HISTORIC AND DESIGN REVIEW COMMISSION

September 19, 2018

HDRC CASE NO: 2018-459
ADDRESS: 1939 W GRAMERCY PLACE
LEGAL DESCRIPTION: NCB 1931 BLK 38 LOT 10
ZONING: R-6, H
CITY COUNCIL DIST.: 7
DISTRICT: Monticello Park Historic District
APPLICANT: Bruce Graham
OWNER: Bruce Graham
TYPE OF WORK: Window replacement
APPLICATION RECEIVED: August 29, 2018
60-DAY REVIEW: October 28, 2018
REQUEST:

The applicant is requesting a Certificate of Appropriateness for approval to replace twelve (12) wood windows with vinyl windows.

Single Hung Vinyl Window with Nail Fin

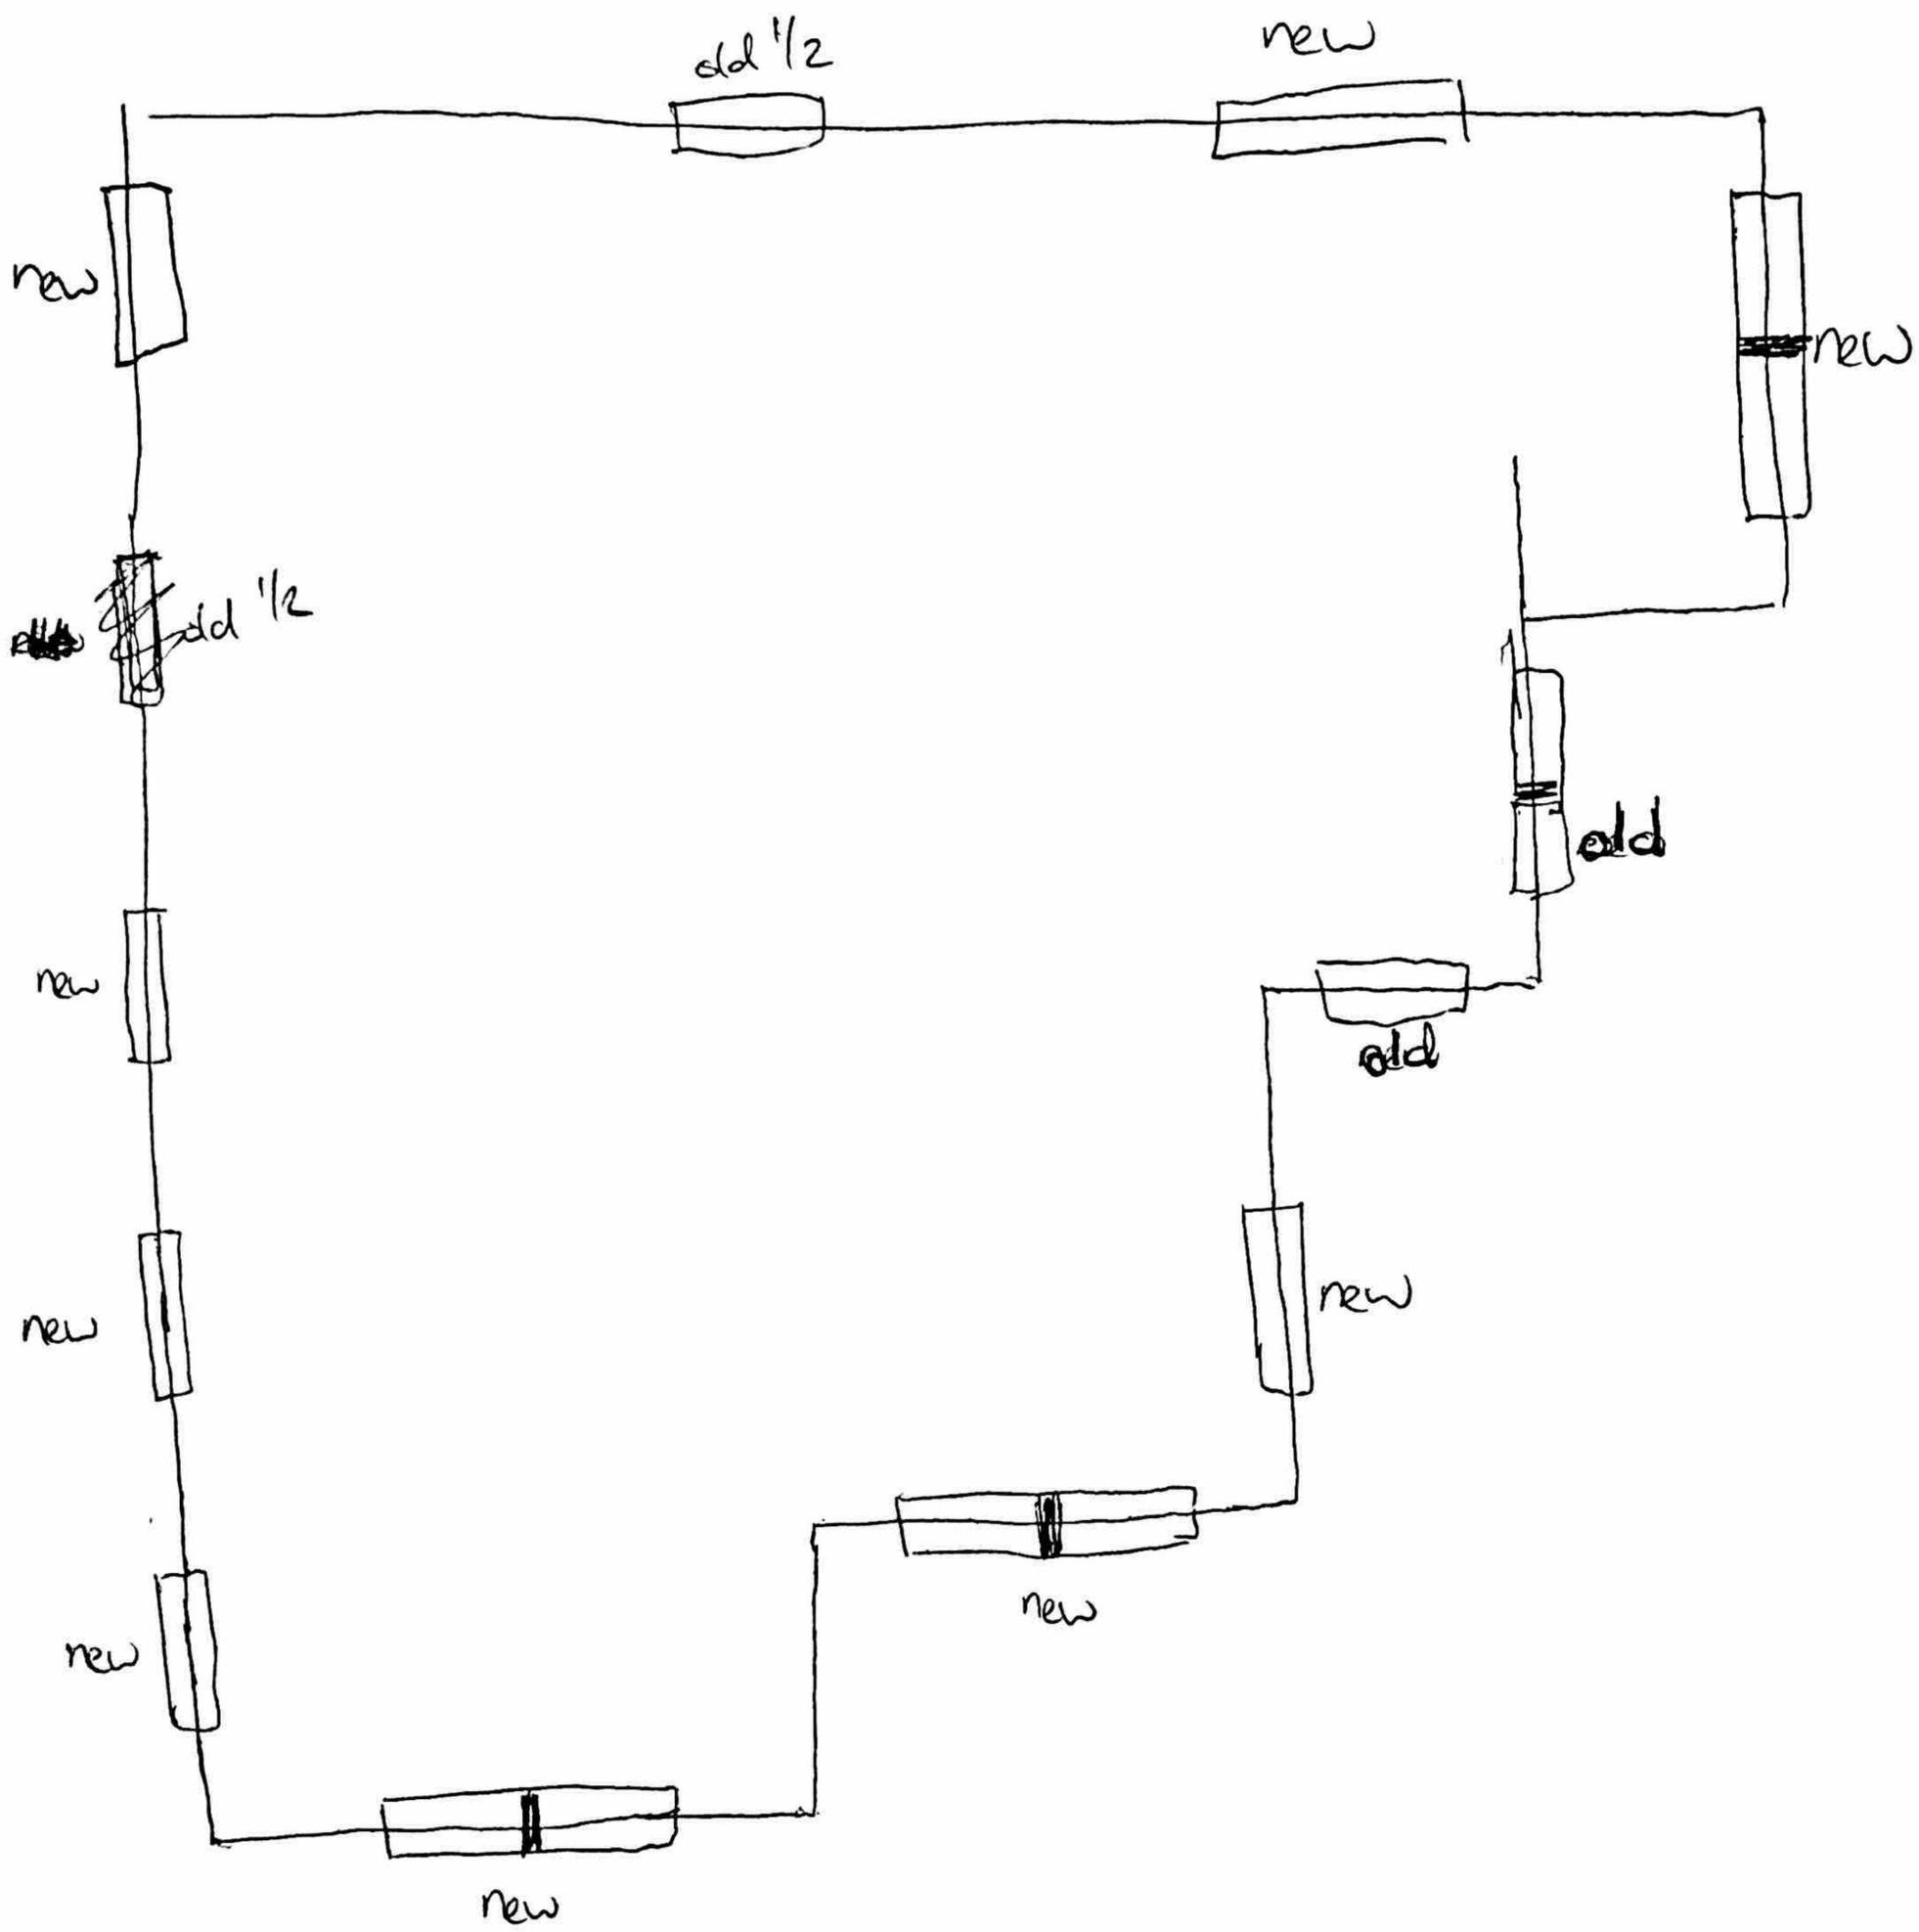
- e. **NEW WINDOWS** – The applicant has proposed to install white one-over-one vinyl windows to replace up to twelve (12) wood windows. The Guidelines for Architectural Features 6.B.iv. notes that new windows are to match the historic or existing windows in terms of size, type, configuration, material, form, appearance, and details. Staff finds that the proposed windows are not compatible in style or materials with the original windows.

Staff does not recommend approval of window replacement based on finding d. Staff recommends repair of any remaining windows. For any window that has been permanently discarded, staff recommends in-kind replacement with the standard stipulations for new windows: *Meeting rails that are no taller than 1.25” and stiles no wider than 2.25”.* *White manufacturer’s color is not allowed, and color selection must be presented to staff. There should be a minimum of two inches in depth between the front face of the window trim and the front face of the top window sash. This must be accomplished by recessing the window sufficiently within the opening or with the installation of additional window trim to add thickness. Window trim must feature traditional dimensions and an architecturally appropriate sill detail. Window track components must be painted to match the window trim or concealed by a wood window screen set within the opening.*

Documentation

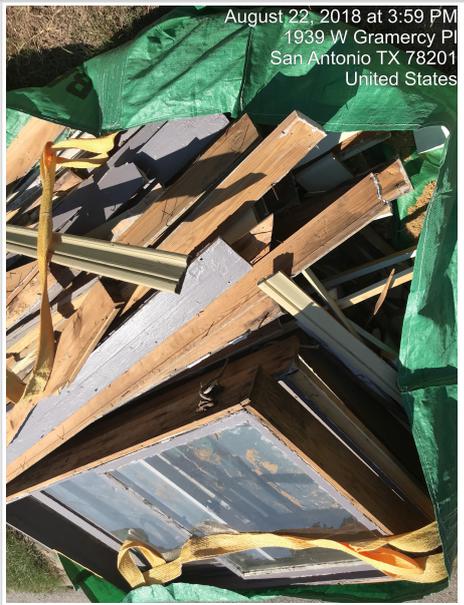
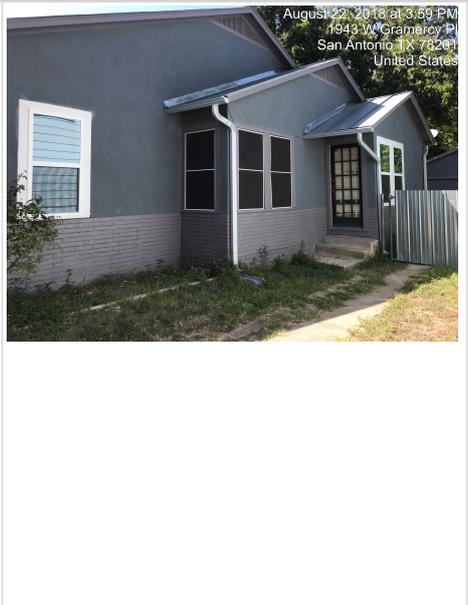
Date	08/22/2018
Time	04:03 PM (-5 GMT)
Context	drive-by
Present Staff	Huy Pham
Present Individuals	None
Types of Work Observed	Exterior Maintenance and Alterations
Amount of Work Completed	Completed
Description of work	Removal of wood windows and installation of vinyl windows and dark mesh window screens. Some wood windows are still on site as of 4pm August 22, 2018.
